ADDENDUM TO THE MITIGATED NEGATIVE DECLARATION IS 19-09 RED HILLS BIOENERGY PROJECT

7130 Red Hills Rd, Kelseyville, CA

PROJECT SUMMARY: The applicant, Scotts Valley Energy Corporation is proposing changes to the previously approved Initial Study IS 19-09, for Use Permit UP 19-05, which allows for the construction and operation of a small-scale bioenergy production facility using woody biomass to produce syngas and biochar, heretofore known as the “Approved Project.” The revised footprint will entail the original 40’ x 50’ building, relocated 40 feet further east of Red Hills Road, the elimination of the 28,000 square foot outdoor biomass processing area, as well as the elimination of the section of the lane and turn around located on the east side of this processing/storage area heretofore known as the “Revised Project”

Figure 2. Revised Project Site Plan, 2023

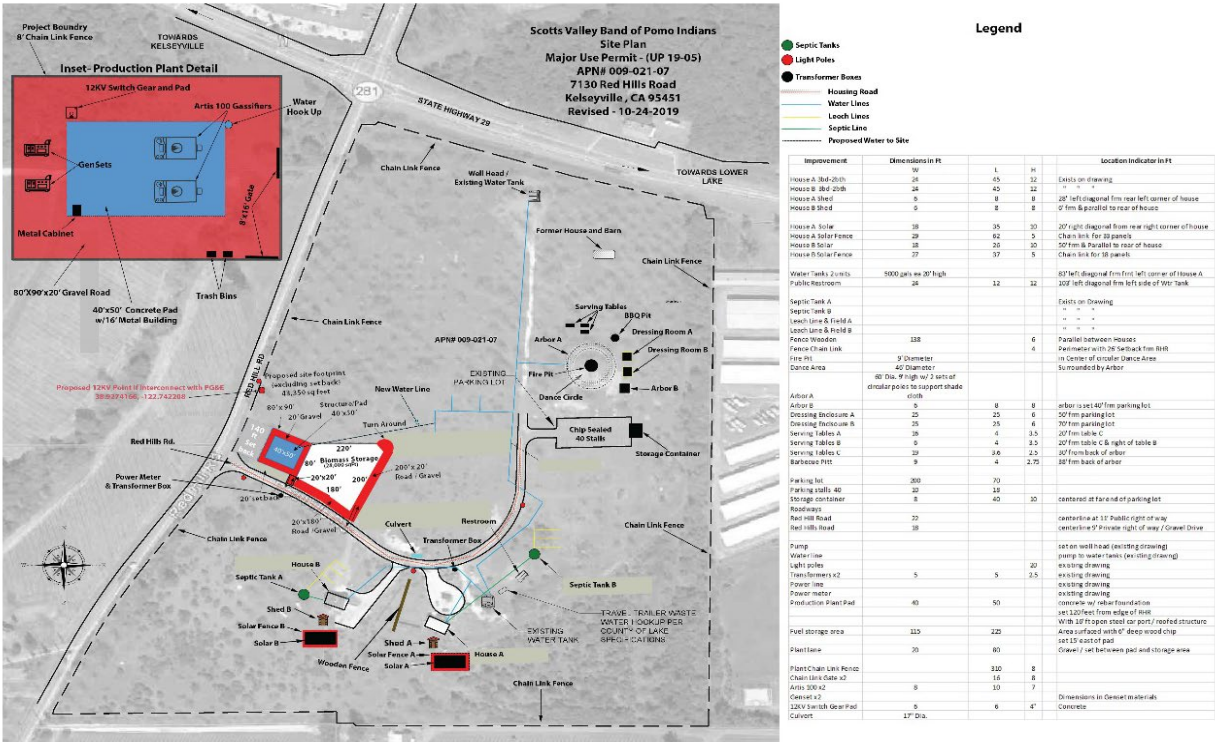
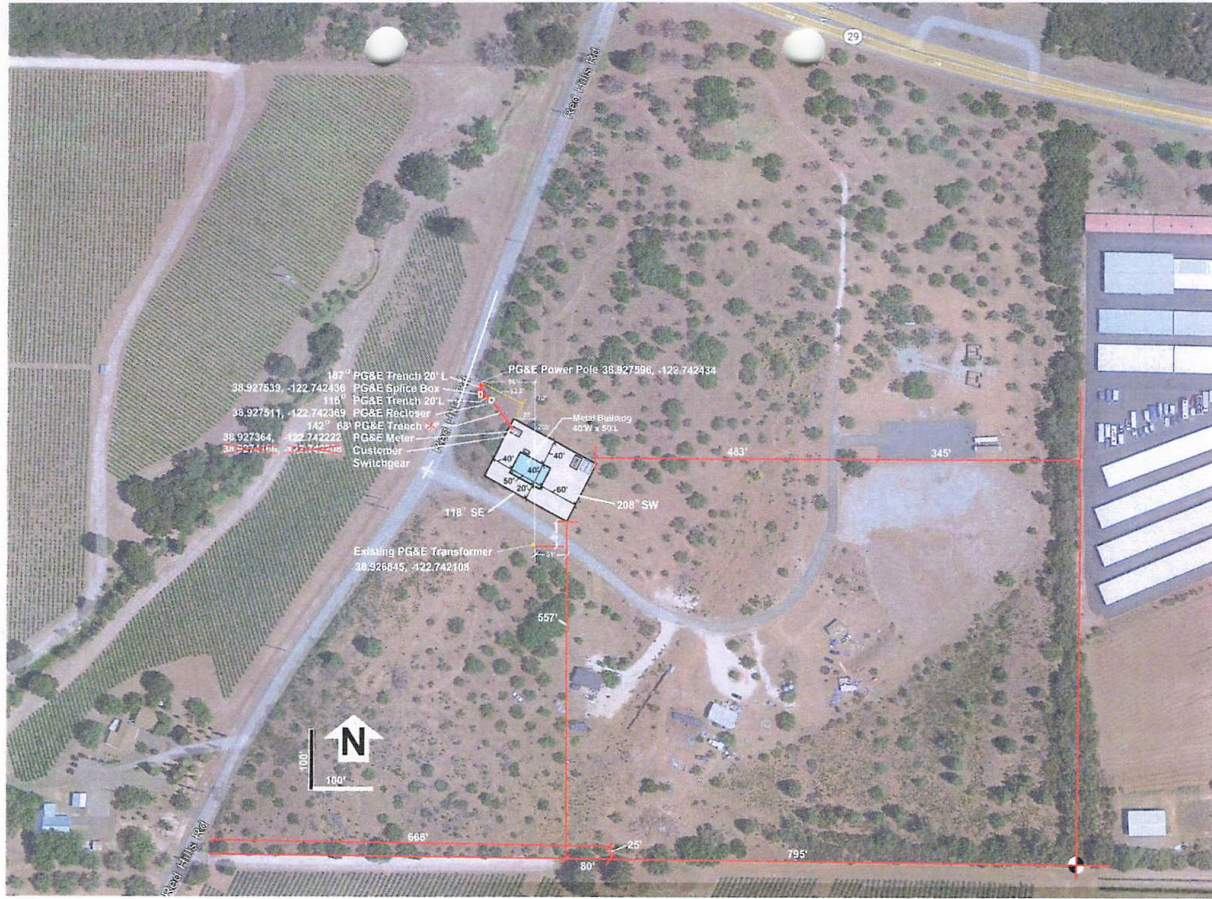
The applicant, Scotts Valley Energy Corporation is proposing changes to the previously approved Initial Study IS 19-09 for Use Permit UP 19-05 which allows for the construction and operation of a small-scale bioenergy production facility using woody biomass to produce syngas, a fuel/gas mixture used in creating synthetic natural gas or for producing ammonia or methanol, and biochar, a by-product of the bioenergy process that functions as an agricultural or forestry soil amendment. The location of the operational facility or building will be relocated approximately 40 feet further east of Red Hills Road or at a distance of approximately 180 feet. This relocation is proposed in order to reduce sound transmission to the residential neighbor to the west, and still operate within the county established noise standards for the commercial neighbor to the east. The Project area will encompass not more than 15,000 square feet, or approximately 28,350 square feet less than the original permitted footprint of 43,350 square feet. This reduction occurs with the elimination of the wood processing and storage area plus the elimination of the section of the lane and turn around located on the east side of this processing/storage area. The revised footprint will entail the original 40' x 50' building with a 40' open space on the north and west sides, 20' space on the south side that is set 20' back from the interior road, and around 60' on the east side. Figure I provides the location of the Approved

Project site footprint and details of the project area. Figure II provides the location of the Revised Project site footprint, and project area.

The location of the operational facility or building will be relocated approximately 40 feet further east, or at a distance of approximately 180 feet from Red Hills Road

The Revised Project area will encompass not more than 15,000 square feet or approximately 28,350 square feet less than the original permitted footprint of 43,350 square feet. This reduction occurs with the elimination of the wood processing and storage area plus the elimination of the section of the lane and turn around located on the east side of this processing/storage area. The 40' x 50' building from the Approved Project would be relocated to ensure a buffer of 40' of open space on the north and west sides, a 20' buffer of open space on the south side (and to the interior roadway), and a 60' buffer on the east side.

The wood-slatted chain link fence of the Approved Project will be reduced to 500 linear feet, while still maintaining a constant 21' distance from the 40' x 50' building. The fence will no longer encompass the outdoor Biomass storage and processing area, which has been eliminated in this project revision.
